Access Compliance Report Public Rights-of-Way (Curb Ramps)

Main Street: MEANDERING_TRAIL Cross Street: PINEHURST_ST Location: NE

ADA ID: RPAT220208141444 Ramp Type: Type 1 - Perpendicular Diagonal Initial Pass/Fail: Fail Overall Compliance: No Severity Score: 16

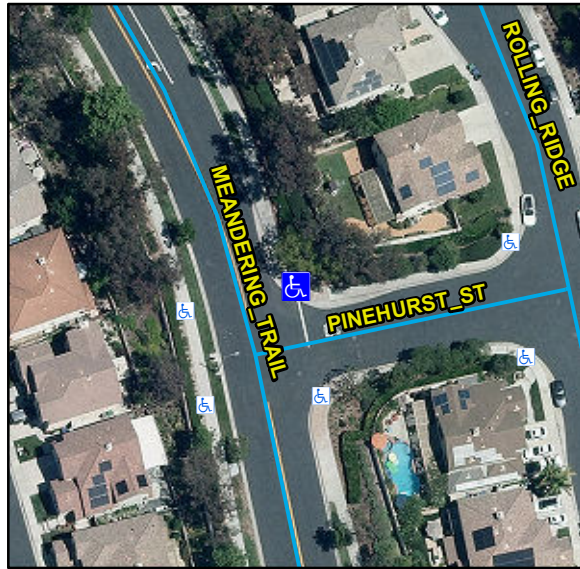
Compliance	Description	Data	Compliance	Description	Data
N/A	Ramp Length (in)	78	N/A	Flare Type LT	
Yes	Ramp Width (in)	62			N/A
No	Ramp Run Slope (%)	9.7	N/A	Flare Slope LT (%)	N/A
No	Ramp Cross Slope (%)	2.2	N/A	Flare Traversable LT	N/A
N/A	Landing Present	N/A	N/A	Flare Type RT	
N/A	Landing Length (in)	N/A			N/A
N/A	Landing Width (in)	N/A	N/A	Flare Slope RT (%)	N/A
N/A	Landing Run Slope (%)	N/A	N/A	Flare Traversable RT	N/A
N/A	Landing Cross Slope (%)	N/A	N/A	DWS Provided	N/A
N/A	Landing Movement Obstructed?	N/A	N/A	DWS Contrast	N/A
	Landing Movement Type	N/A	N/A	DWS Length (in)	N/A
N/A	Landing Shared	N/A	N/A	DWS Full Width	N/A
N/A	Clear Space	Yes	N/A	DWS Offset Left (in)	N/A
N/A	Clear Space To Crosswalk (in)	N/A	N/A	DWS Offset Right (in)	N/A
N/A	Marked Crosswalk 1	No	N/A	Marked Crosswalk 2	No
	Crossing 1 Direction	W		Crossing 2 Direction	S
	Marked Crosswalk 1 Width (in)	N/A		Marked Crosswalk 2 Width (in)	N/A

N/A	Ramp Inside Crosswalk 1	N/A	Yes	Ramp Inside Crosswalk 2	N/A
	Crossing 1 Slope (%)	1		Crossing 2 Slope (%)	1.5
	Crossing 1 Cross Slope (%)	3.6		Crossing 2 Cross Slope (%)	1.2
N/A	Gutter Ponding	N/A	N/A	Curb Slope	2.8
Yes	Gutter Lip Height (in)	0		Road Run Slope (%)	1.2
N/A	Gutter Run Slope (%)	N/A		Road Cross Slope (%)	2.2
N/A	Gutter Cross Slope (%)	N/A			
Yes	Overall Surface Condition: Acceptable		No	Perp Joint Present	No
	Cross Gutter Present?	No		Spandrel Present?	No
	Replace Cross Gutter?	N/A		Replace Spandrel?	N/A

Remove & Replace Curb Ramp With Two New Directional Ramps or Equivalent.
